Highway Development Control Consultation Response

Planning Application Ref: PL/2026/01341

Site Address: Land at Midge Hall Nurseries, Royal Wootton Bassett, Swindon, SN4 8ER

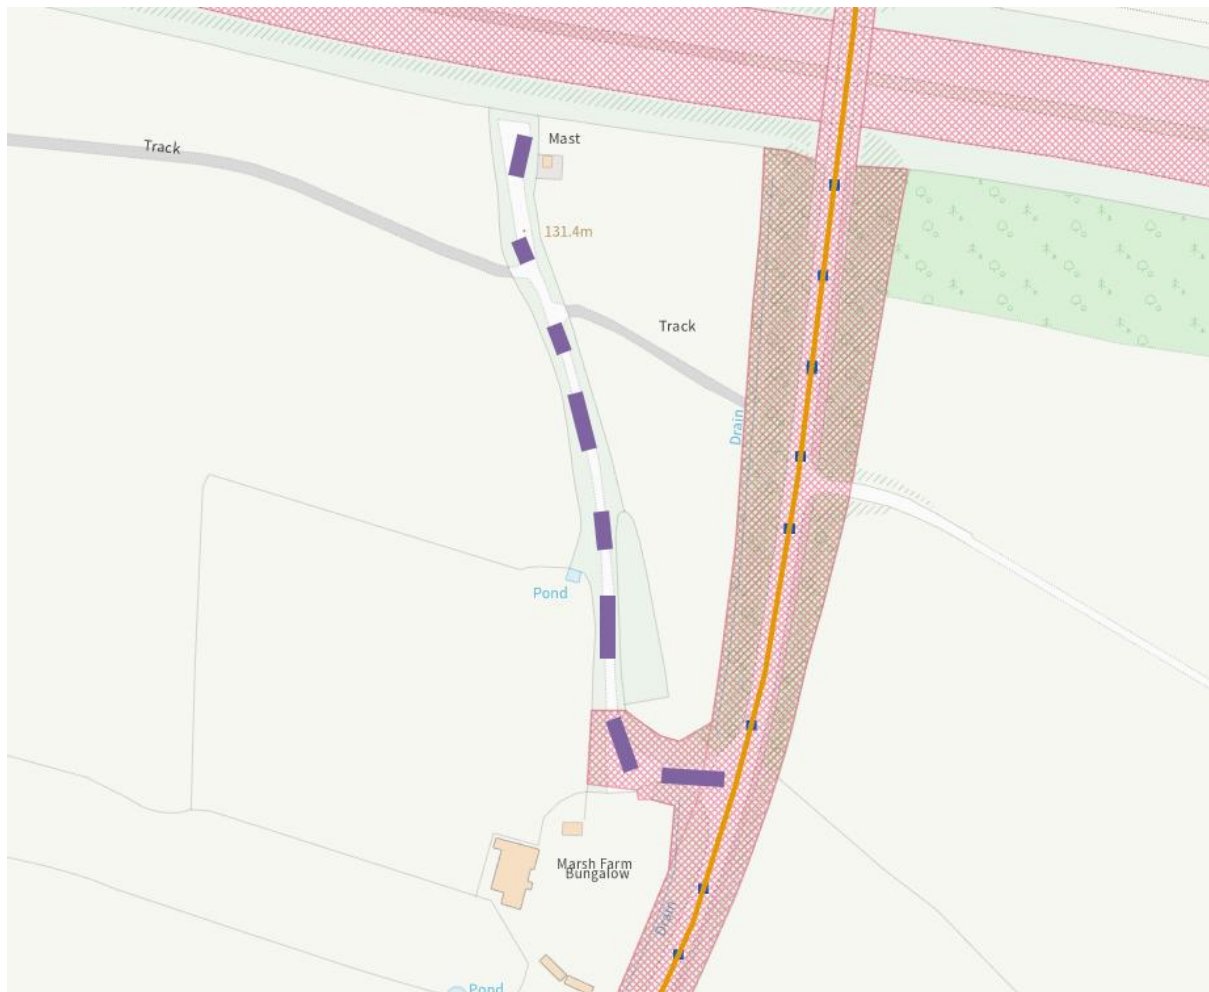
However, I note the access arrangements within the application are incorrect, the map extract above shows the location of the access from the public highway. All routing for HGVs should be via the south avoiding the Weight Restrictions within the Parish of Purton. Therefore, a holding objection is required for the applicant to provide an updated plan 100 1A indicating the access arrangements from the classified C414 and a revised routing plan from the M4 junction 16 via the Coped Hall Roundabout.
